Application Number: 22/03783/APP
Proposal: South East Aylesbury Link Road (Phase 2) improvement scheme including dual carriageway (for the Stoke Mandeville Relief Road and to provide connection with the South West Aylesbury Link Road), new roundabout, lighting columns, maintenance bays and access points, diverted public right of way, uncontrolled crossing, provision of two shared cycle/footways, noise bunds and barriers, relocated field accesses, grass verges, road restraint systems, mammal tunnel, flood compensation storage areas, woodland planting, landscaping, habitat creation, drainage ponds and swales, substation and associated infrastructure and earthworks
Location: Field To North Of Hall End Adjacent To Lower Road Stoke Mandeville Buckinghamshire.

Thank you for your request for comments on the South East Aylesbury Link Road (SEALR) Phase 2 Transport Assessment which was submitted on the 10th November 2022.

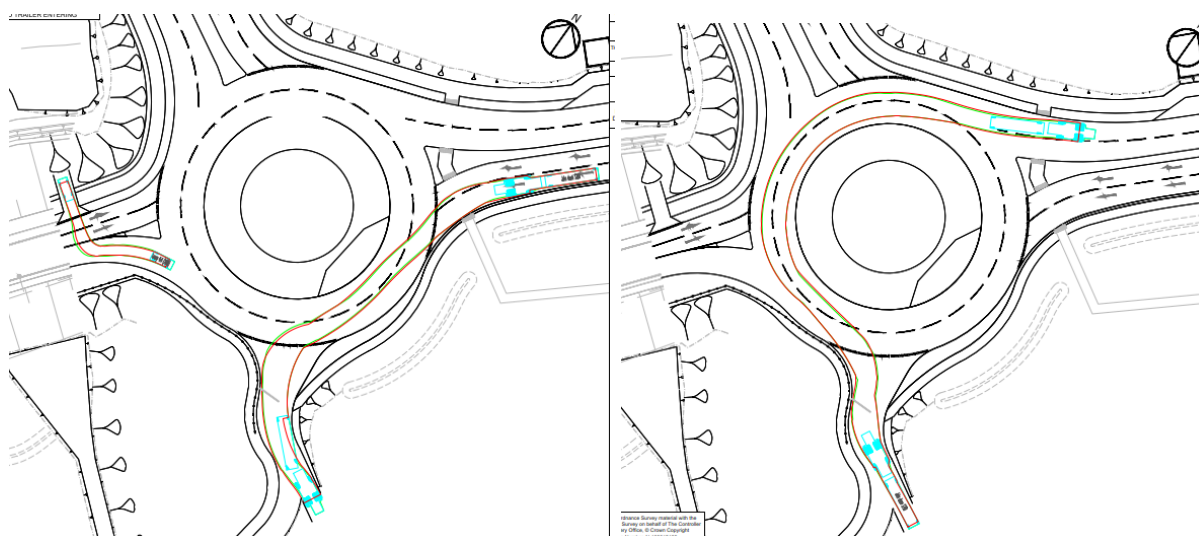
Swept path analysis drawings have been provided of the western SEALR Phase 2 / SWALR/ SMRR Roundabout and demonstrate that an articulated HGV can stay in its lane on the roundabouts, with the exception of the gated field access on the western roundabout where the vehicle is required to use both running lanes to access and egress the field access. An exert is shown below.

Although this was not raised in the September 2022 review of the Road Safety Audit, BC is concerned that this layout would result in collisions on the roundabout. BC require the applicant to relax the radius

of the field access, in line with the original design, which would allow large vehicles to access and egress the site using one running lane only.

- The applicant is required to relax the radius of the field access, in line with the original design, which would allow large vehicles to access and egress the site using one running lane only.
- The applicant is required to relax the radii of the HS2 access on the western approach and change it into a left in left out only access to remove right turn movements into the access.
- The applicant is required to remove the maintenance bay on the Roundabout and reposition it in a more suitable location.

1) *Proposed maintenance/ access track parallel to westbound carriageway of link road.*

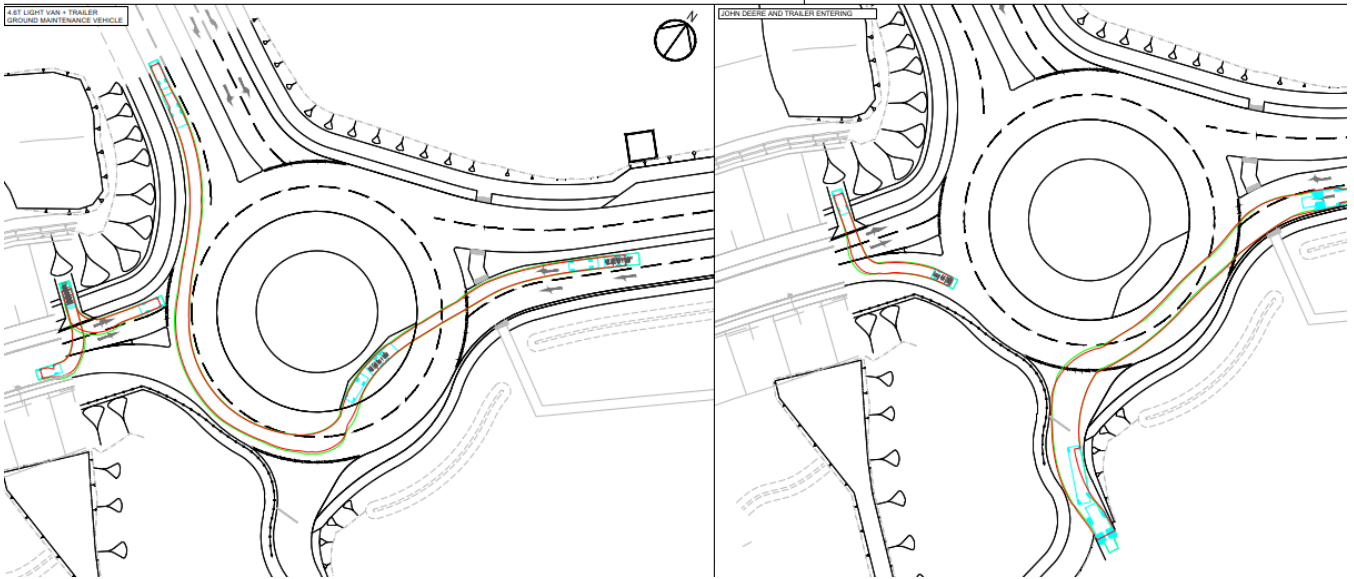
“A 2m wide maintenance track (the purpose and likely usage of which is unclear) is proposed adjacent and parallel to the westbound phase 2 link carriageway, segregated only by a narrow verge. If this track is to be used by vehicles, there are the following risks:

- *Westbound drivers on the link road may be distracted/ confused by the presence of vehicles on their nearside on the track, particularly if they have headlights on for example;*
- *There may be inadequate clearance between track users and vehicles in the westbound nearside lane of the SEALR; and*
- *Lighting columns are positioned within the maintenance track which may result in vehicles encroaching into the link road to bypass them; and*
- *Part of the track sits behind the proposed ‘indicative vehicle restraint system’ midway along the link. Track users will therefore not be protected from the water hazards in this area and it is unclear whether they will have adequate working width behind the barrier and between the water hazards. Users may be at risk of injury should a vehicle collide with the barrier or should their vehicle enter the water.*

The above concerns could result in unsafe conditions for road users on the link road and the maintenance track.”

BC are concerned about the proximity of the maintenance track to the road and require the track to be positioned further south.

- BC are concerned about the proximity of the maintenance track located south of the westbound carriageway to the road and require the applicant to reposition the track further south.
- The applicant is required to reposition the substation maintenance bay, which is currently located at the exit of the western roundabout on the eastbound section of SEALR Phase 2, to a location near the entry of the roundabout, possibly at the northern (SWALR) arm.

2) *Proposed gated maintenance access on northern side of western arm of roundabout. Access point located close to roundabout entry/ exit. Swept paths indicate potential conflicts.*

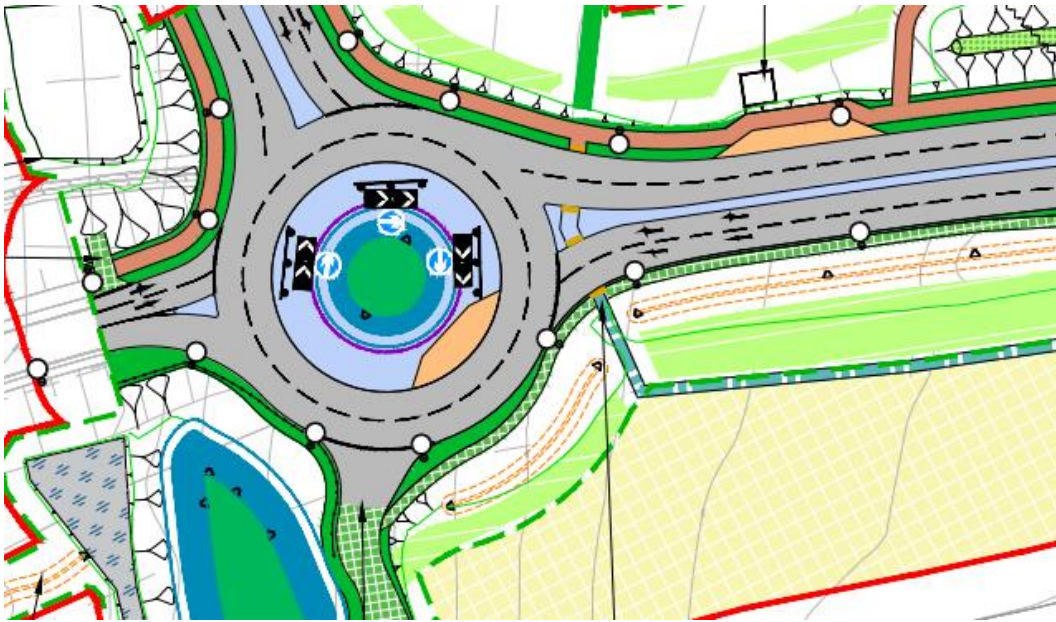
“The location of the HS2 maintenance access close to the roundabout is of concern, i.e. in terms of the impact it would have on the roundabout (gap seeking right turners waiting on the exit arm to turn right into the access being struck by other vehicles exiting the roundabout or rear end shunts on the western arm approach as following drivers are unlikely to expect vehicles to be slowing/ turning immediately upstream of the access).”

However, if the movements are infrequent, and undertaken by the types of vehicles as understood in communications from the design team, namely “the design vehicle being a 4x4 vehicle. Use of the access will be infrequent and will only be used for embankment maintenance and grass cutting” then this is not expected to constitute a significant road safety issue. Although it is acknowledged that 4x4 vehicles are smaller than the agricultural vehicles which were shown turning in/ out of the access in the initial swept path layouts audited, the design team should ensure that these vehicles are still able to turn in/ out of the access safely/ without slowing too significantly on the approach

It is recommended that the access is relocated further west on this arm of the roundabout and that wider radii is used to ensure traffic accessing/ exiting the access is able to do so without encroaching on the opposing traffic lane.”

BC are concerned that right turning vehicles entering and exiting this access need to cross opposing lanes which would increase the risk of collisions. BC require the radii to be relaxed and changed into a left in left out only access to remove right turn movements into the access.
